Minnesota Department of Transportation

2000 Bridge Inspection Report Bridge #2440: Hwy. 65 over the Mississippi River (3rd Ave. Bridge)

Inspection Date: June 16 & July 31, 2000

SPAN #1
CAP A

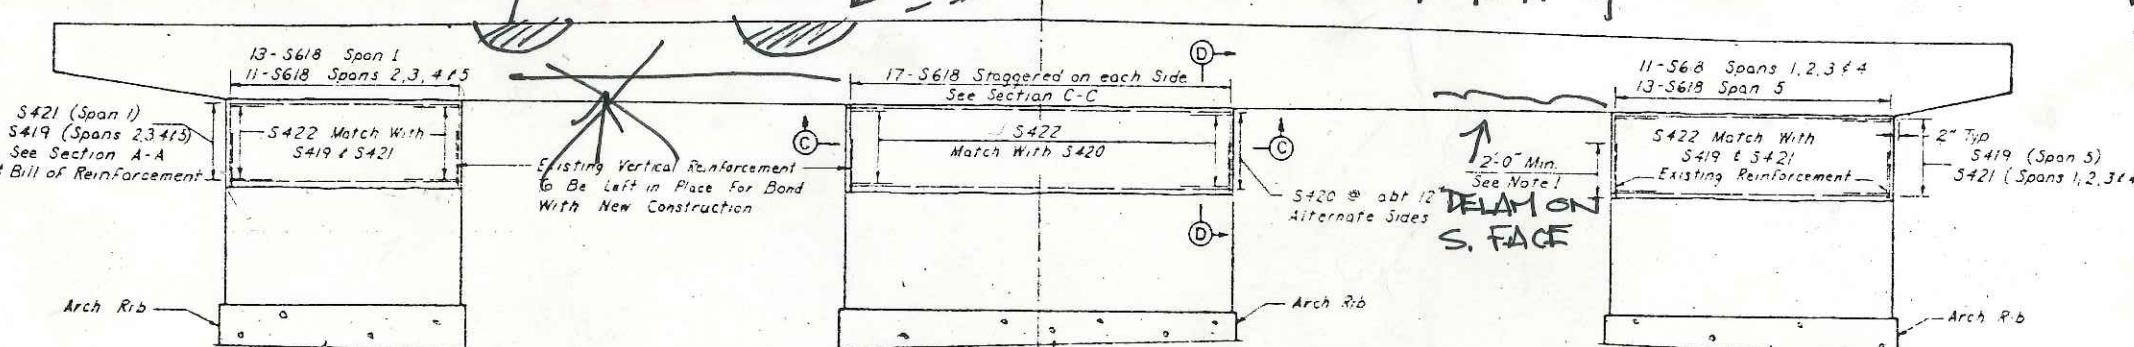
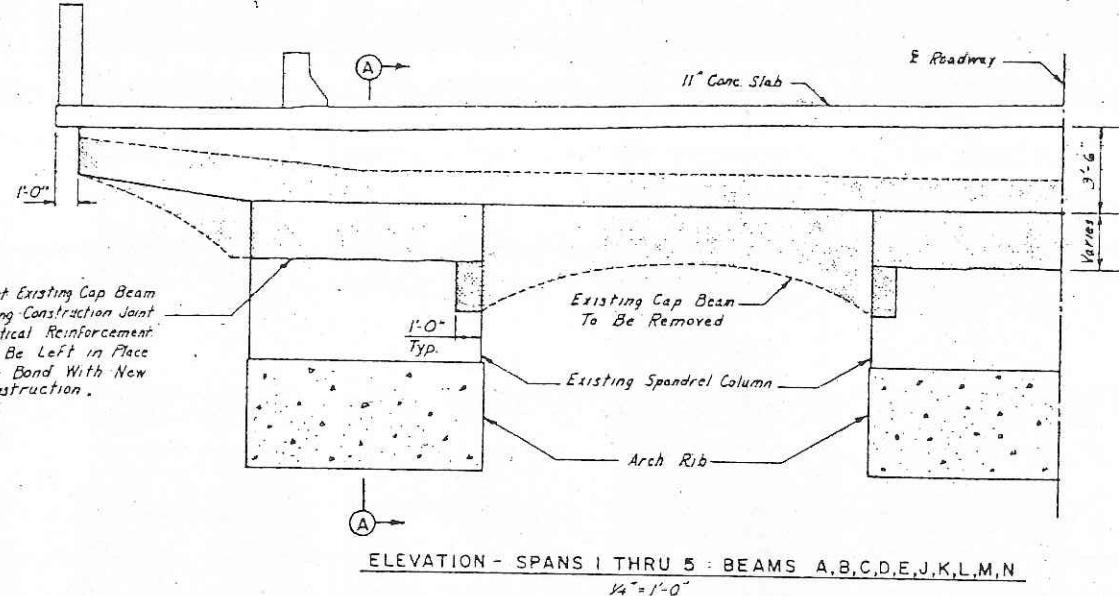
DECK HAS WATER SAT (SOME DELAM)
EXTENDING FROM 8" TO 16" OUT
FROM FACE OF CAP - ENTIRE LENGTH

SPAN # 1
CAP F
NO SPALLS
MINOR DECK DETERIORATION
CAP G HAS 5 LF SPALL SAME LOCATION ON BOTH N. FACE

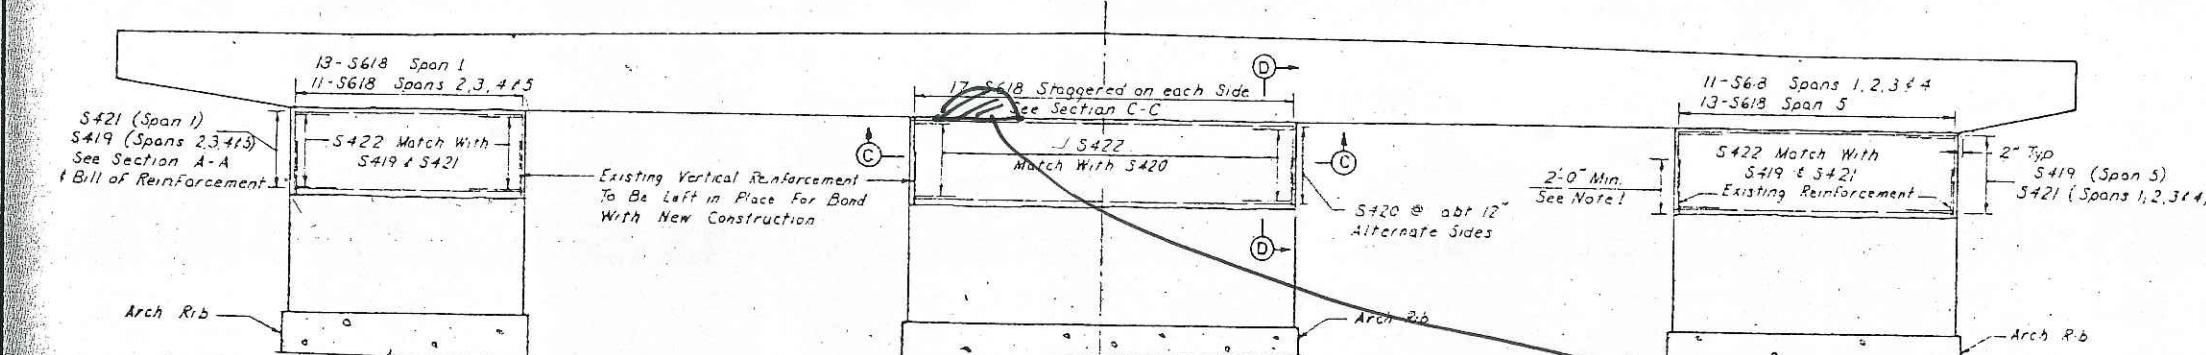
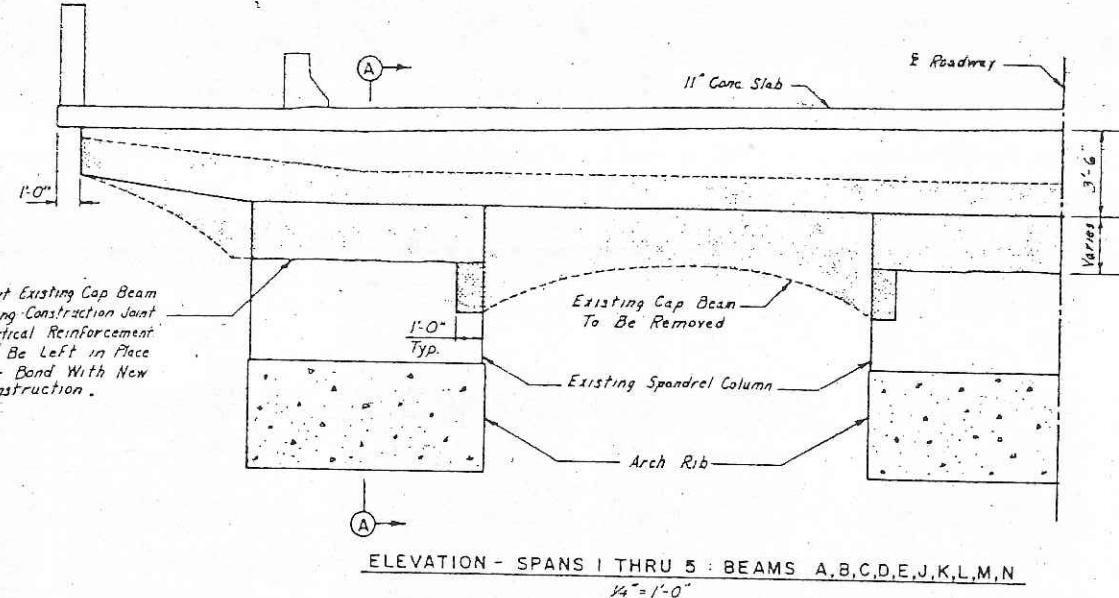
CAP H HAS AXA
SPALL ON N. FACE (EAST END)

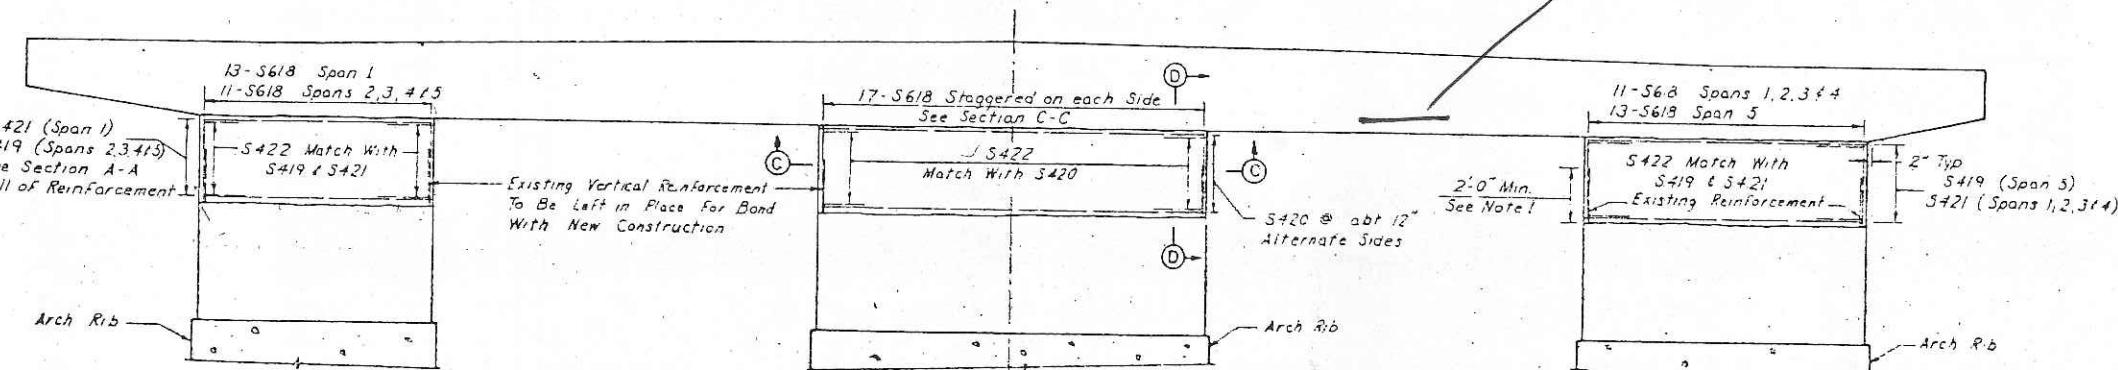
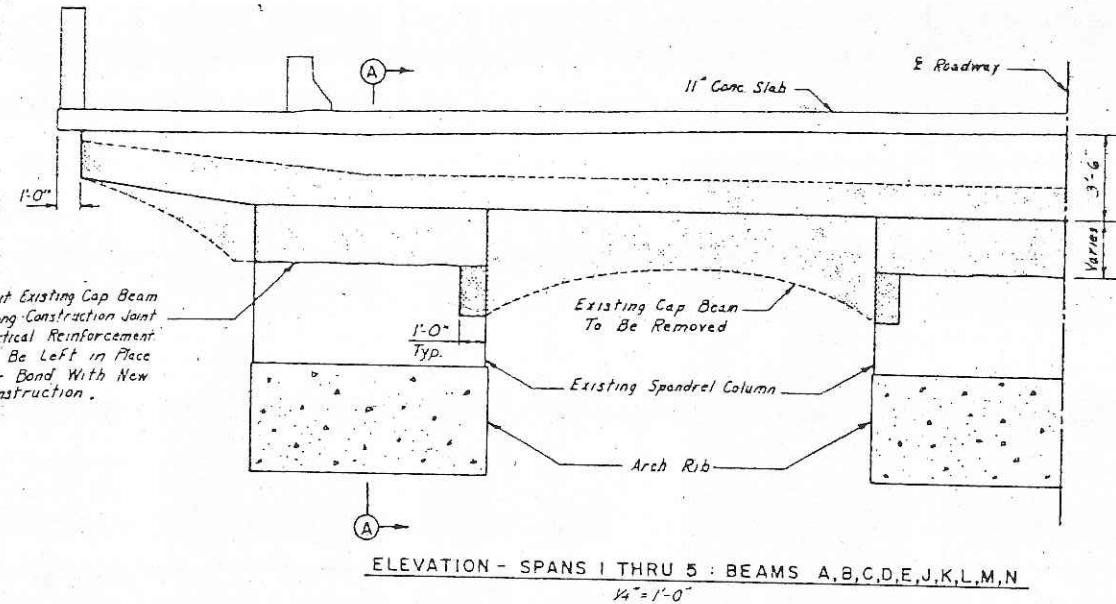
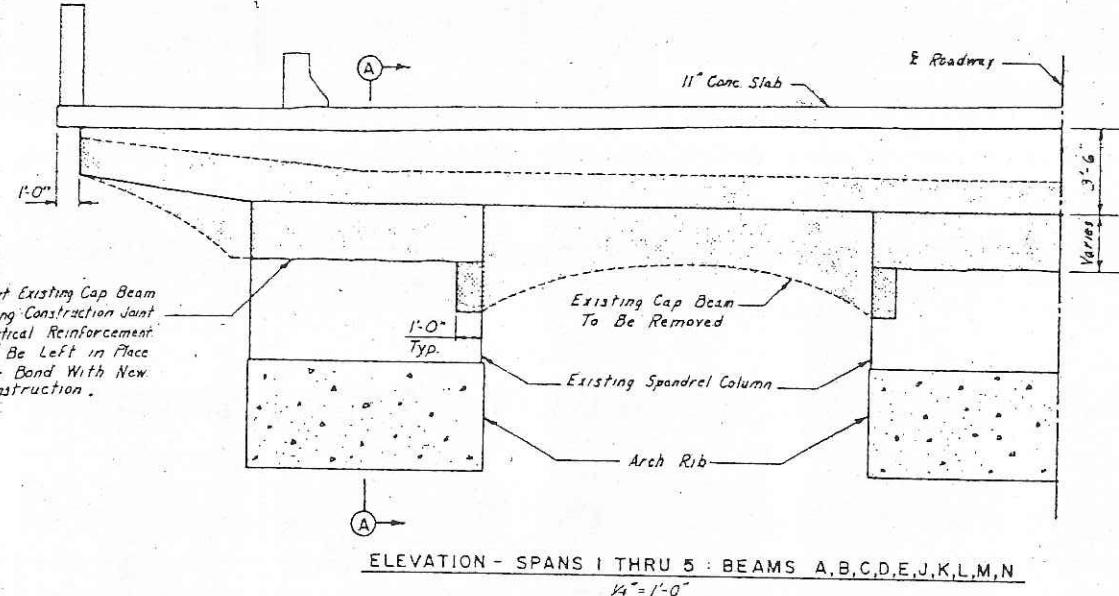
DECK HAS AREAS OF 6"- 36" DELAM (WATER SAT.)

SPAN # 2
CAP I

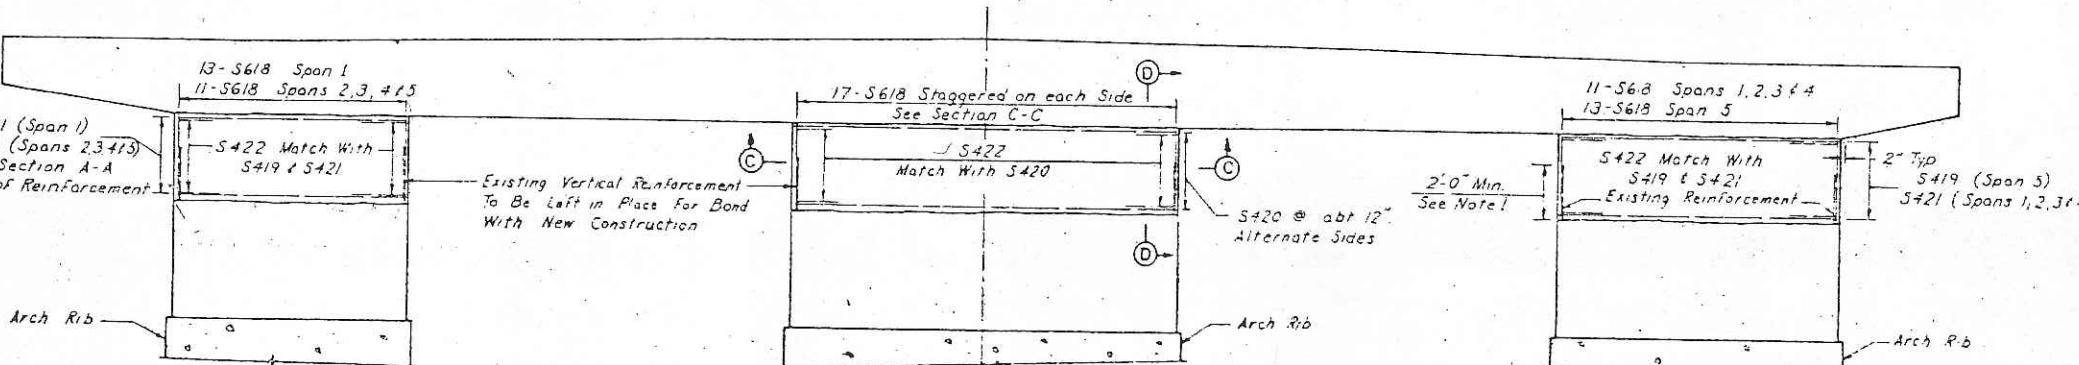
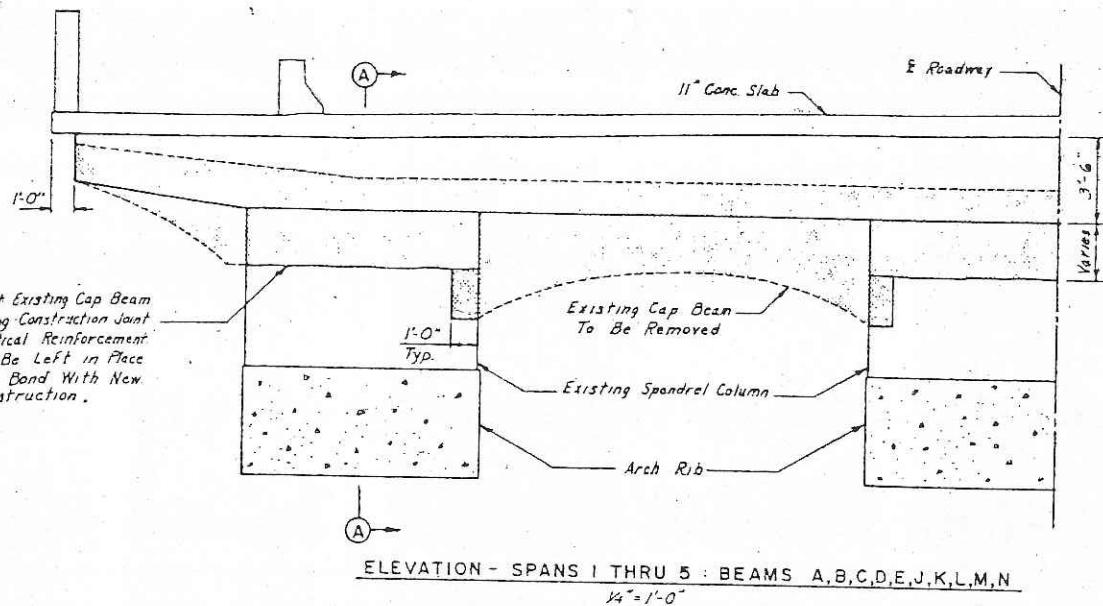
MINOR DECK DET.

SPAN # 3
CAP A

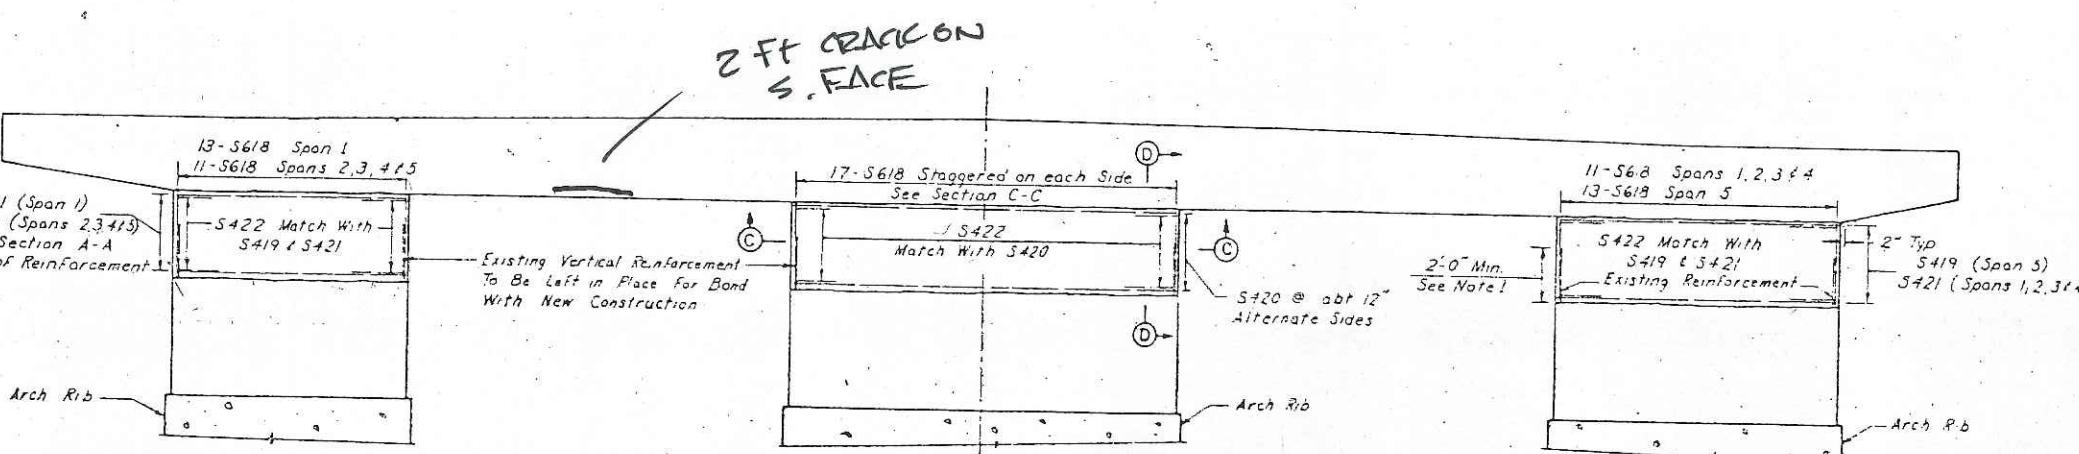
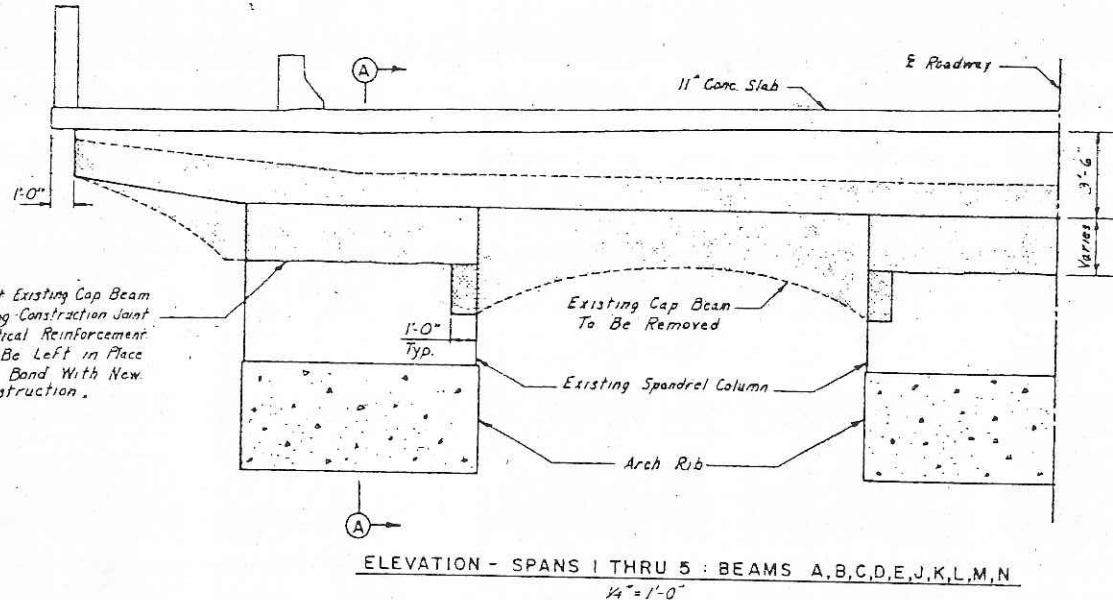
DECK HAS WATER SAT
& DELAM 0"-18"
SMALL SPALC

SPAN #4
CAP F

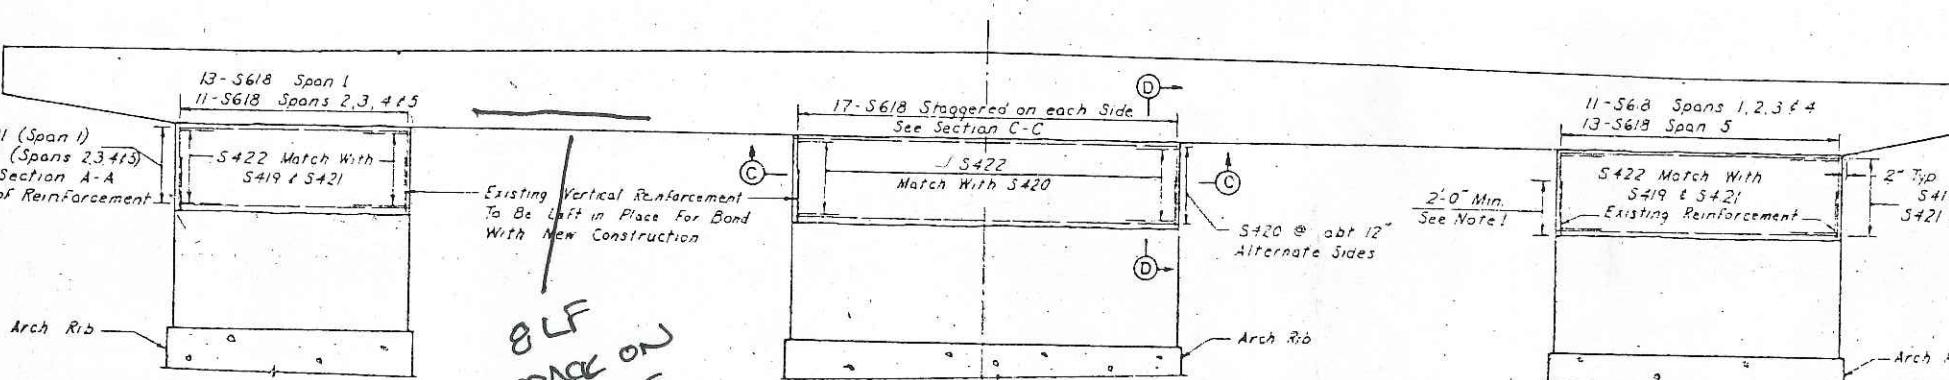
DECK MINOR - MODERATE
WATER SAT

SPAN # 5

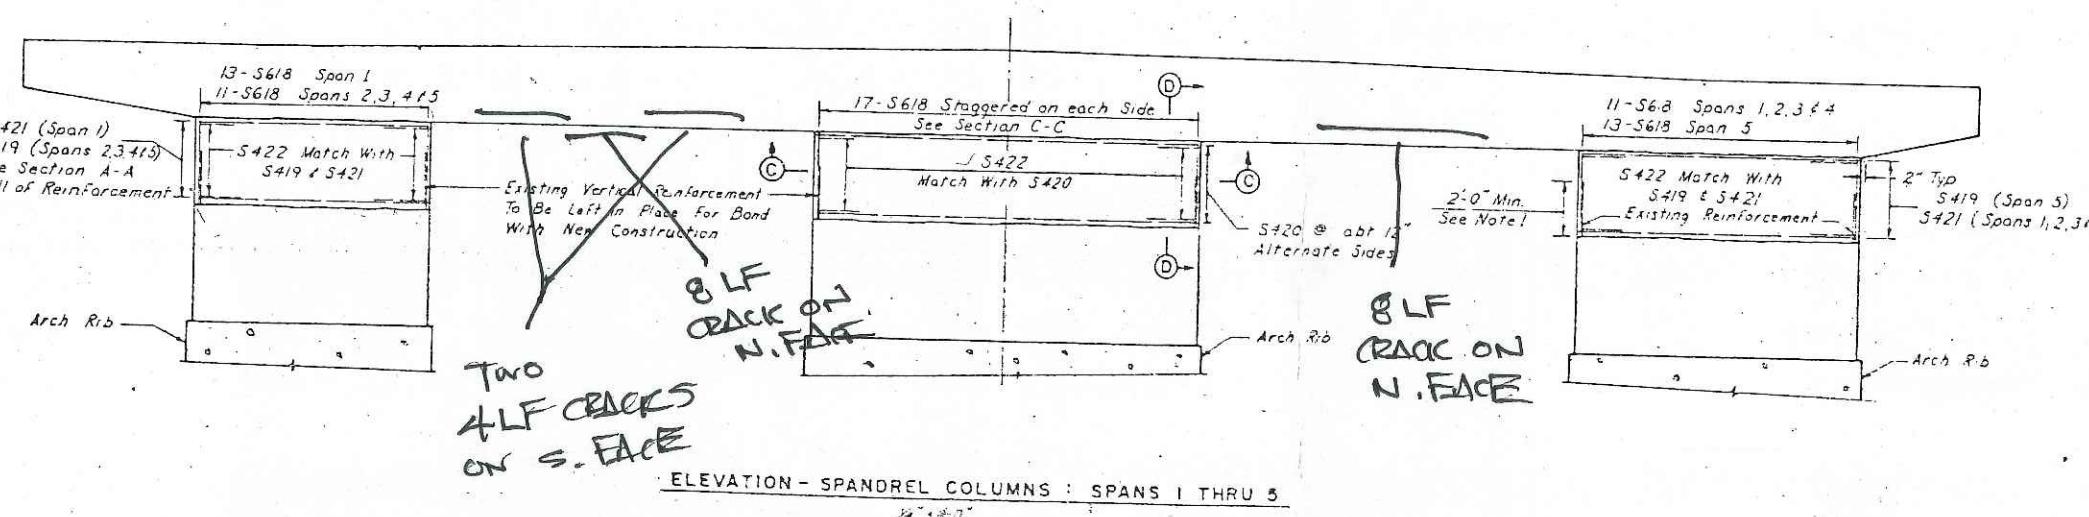
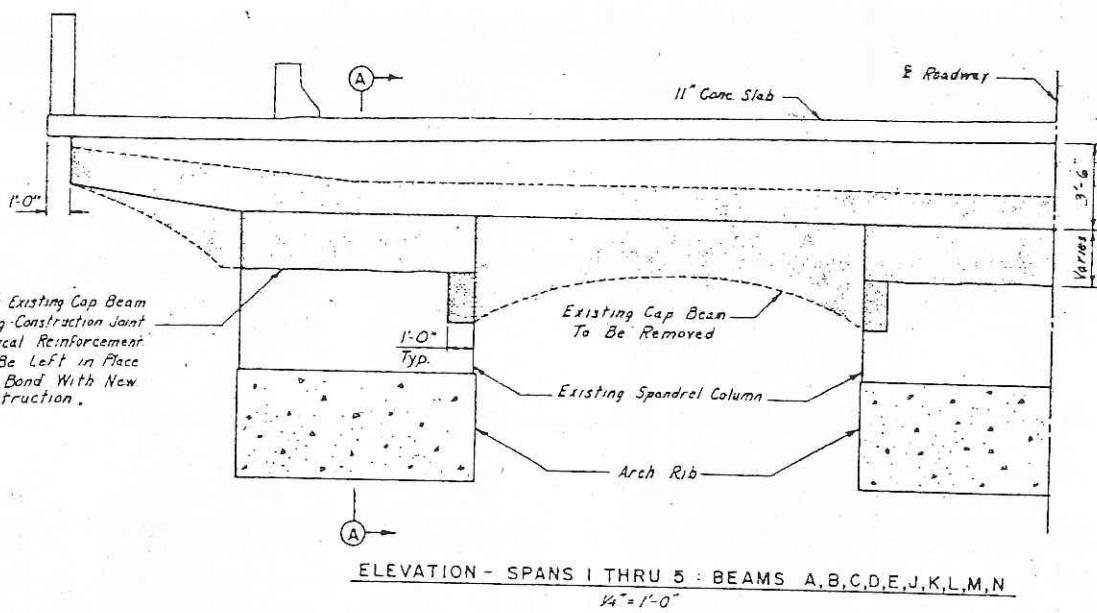
DECK HAS

6-12" WATER SAT
SOME DELAMS
